DOWNTOWN/BALLOUGH ROAD REDEVELOPMENT AREA BOARD

5. **American Born Salvage**
 - a. **DEV 2015-024, SITE PLAN**

Request by Colleen Miles, Land Development Resource Group, LLC, on behalf of American Born Salvage for site plan approval in the M-1 zoning district. The site is located at 142 South Segrave Street. (Reference: 1993 Land Development Code, as revised, Article 4§8.2)

MINOR SITE PLAN MODIFICATION FOR AMERICAN BORN SALVAGE

SITE LAYOUT PLAN
AMERICAN BORN SALVAGE
142 SOUTH SEGRAVE STREET
DAYTONA BEACH, FL 32114

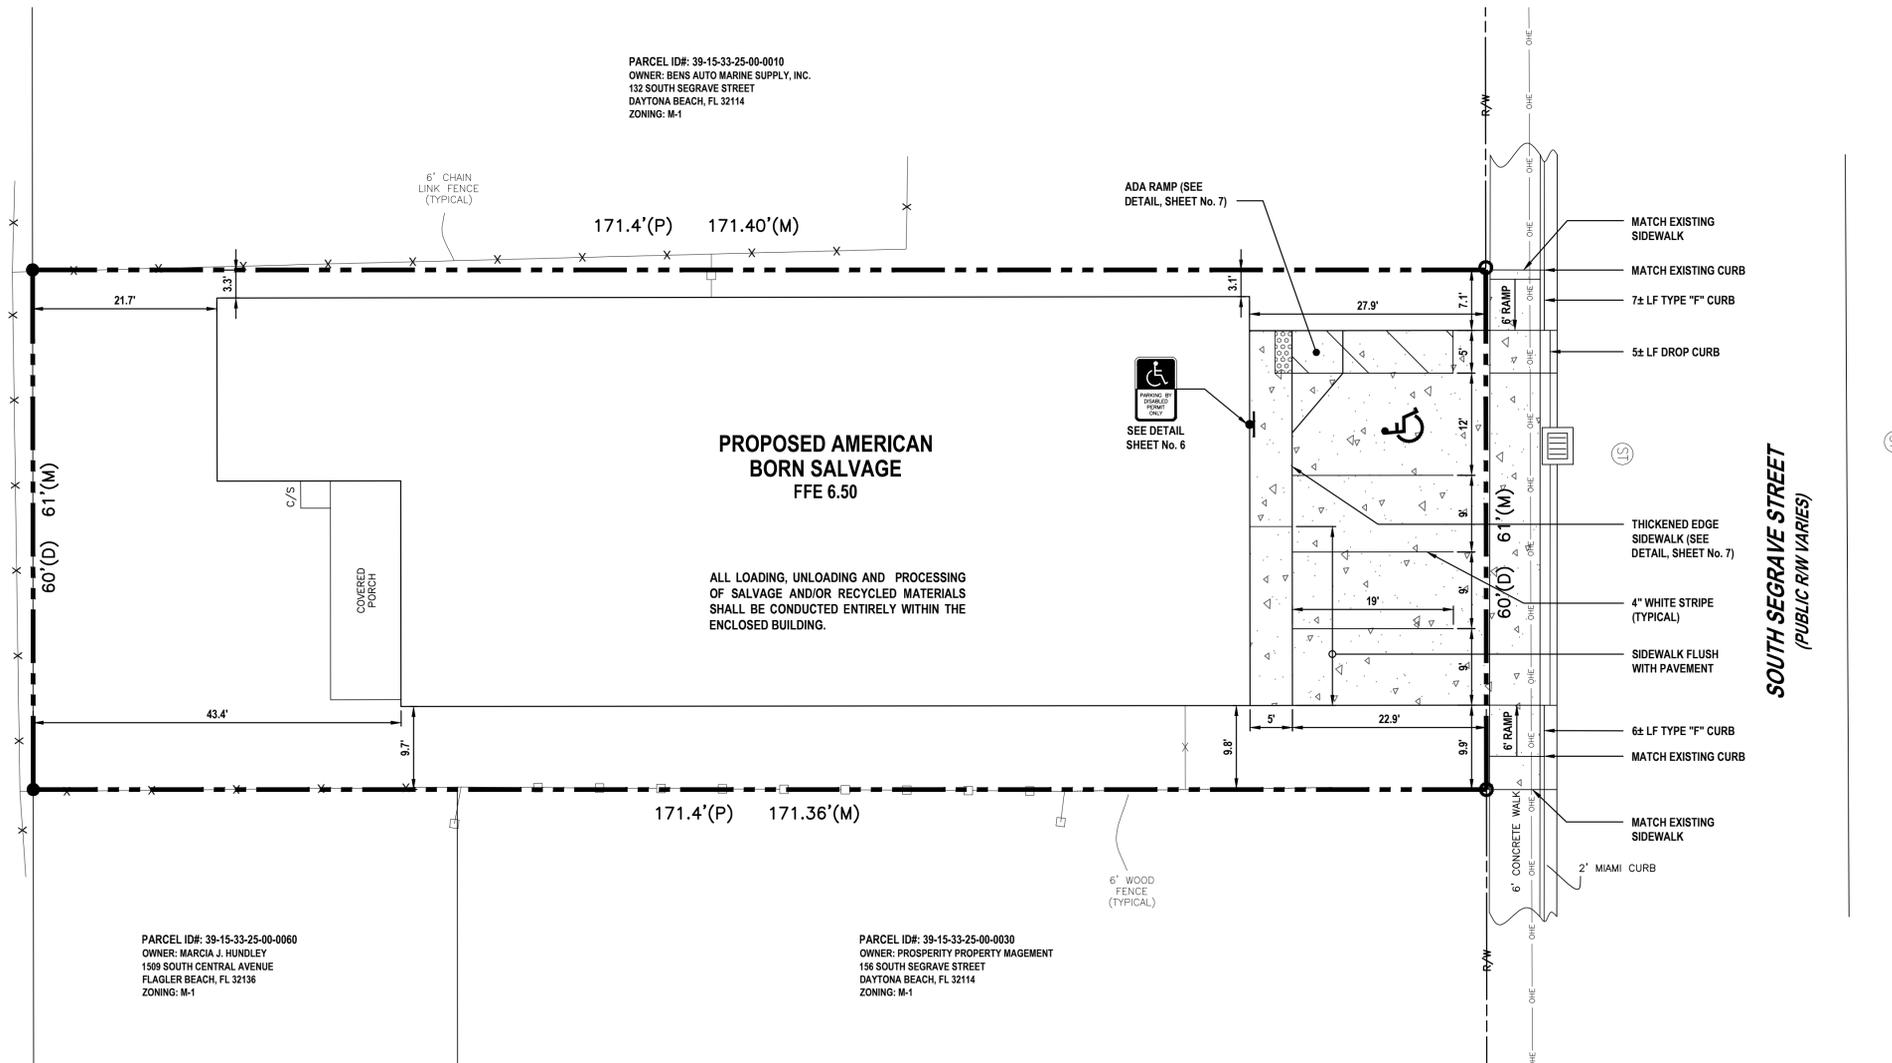
Parking & Traffic Flow: The project is required to provide five parking spaces. The site plan shows 5 parking spaces in front of the building requiring vehicular traffic backing into the right-of-way. Generally, the LDC prohibits parking

arrangements that require vehicular traffic to back into right-of way from private property. The applicant has provided architectural elevations with new overhead garage door on the front elevation, but the site plan does not show a drive isle to the new garage door. The site plan will need to be revised to show a drive isle to the garage door and a reduction of parking spaces to three. The applicant has also submitted a Board of Adjustment application to request a variance to reduce the required parking spaces to three and to allow backing into and/or out of a public right-of-way.

Staff recommends that the Downtown Redevelopment Board **APPROVE** the conditional use and **APPROVE** the site plan for the project known as American Born Salvage, located at 142 South Segrave Street, subject to the site being revised to include a drive isle to the new garage door, the approval of the variances by the Board of Adjustment to reduce the required parking spaces to three and permit vehicular backing into a public right-of-way, and any outstanding staff comments.

LANDSCAPE PLAN
AMERICAN BORN SALVAGE
142 SOUTH SEAGRAVE STREET
DAYTONA BEACH, FL 32114

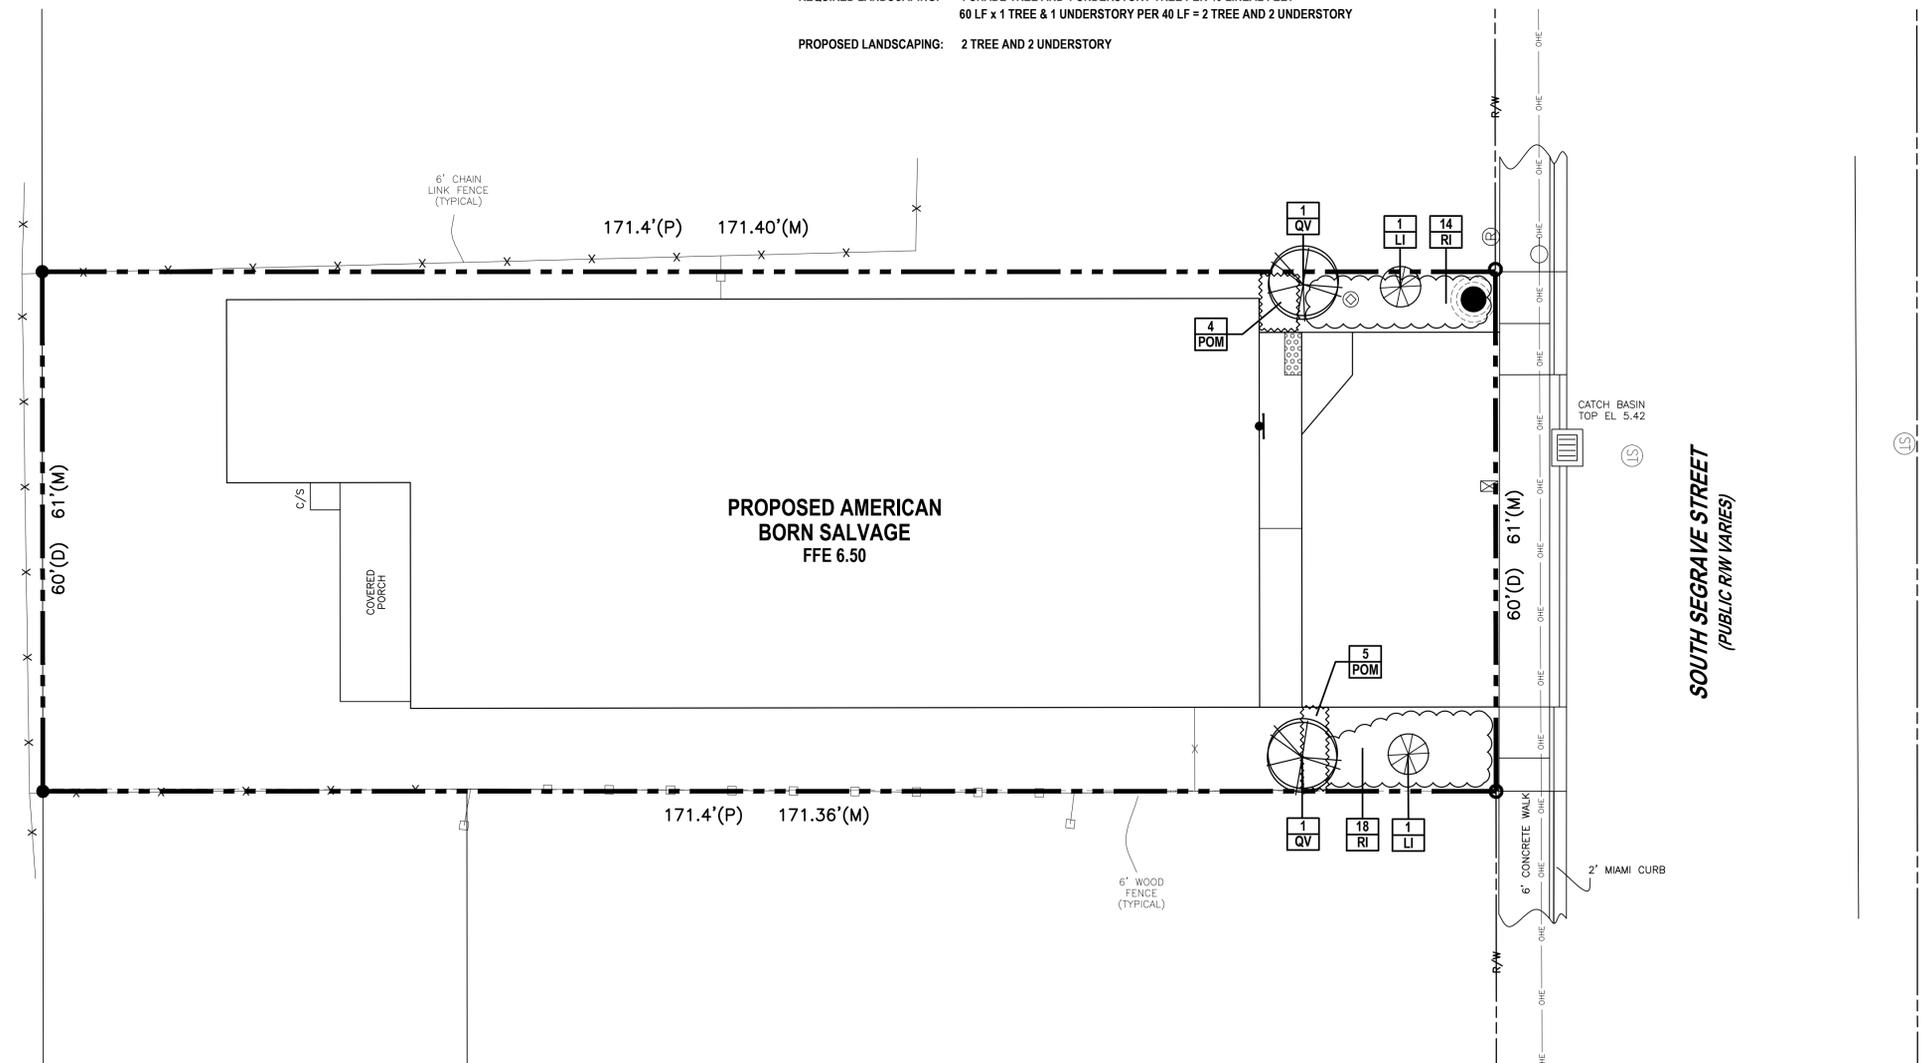
Site Landscaping: The proposed landscaping plan is for an existing developed site. The 1993 LDC requires sites in redevelopment areas be brought into compliance with the landscape requirements in Article 18§2 to the greatest extent possible based on the physical constraints of the site. The constraints of the site with the existing structure and pavement areas allows for lot perimeter landscaping in the front yard. The landscaping plan complies with the requirements in the LDC. Attached in this packet are the landscape plans that detail the proposed landscaping improvements.

FRONT ELEVATION

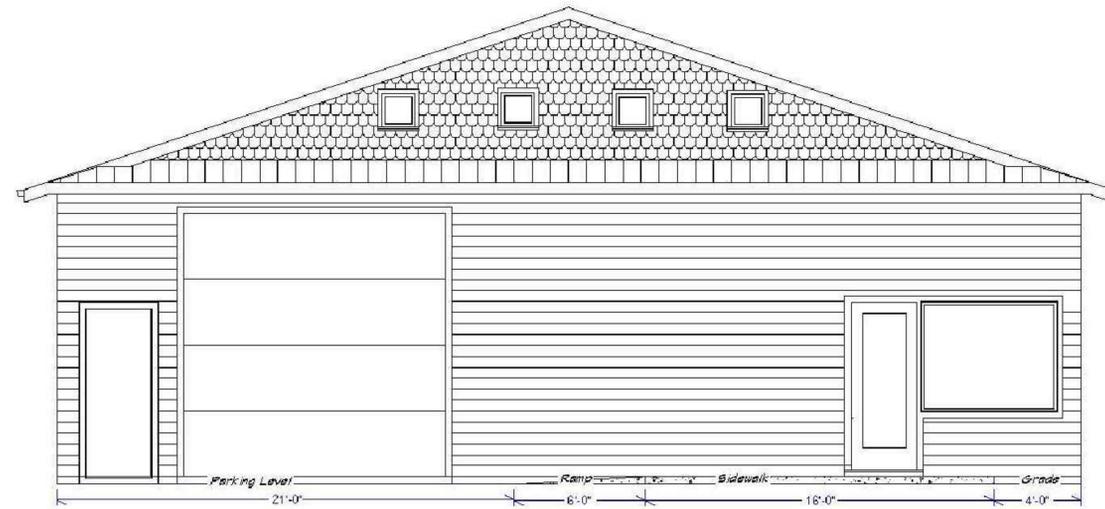
Project architecture: The existing building is designed in a commercial vernacular style of architecture. The applicant is proposing to preserve the building architecture. The applicant is proposing to remove the existing dock/walkway in the front of the building. A large overhead garage door will be installed to allow for the truck to enter into the building to unload materials. The building will be repainted to provide an overall unified appearance. The proposed improvements meet Redevelopment Design Standards.
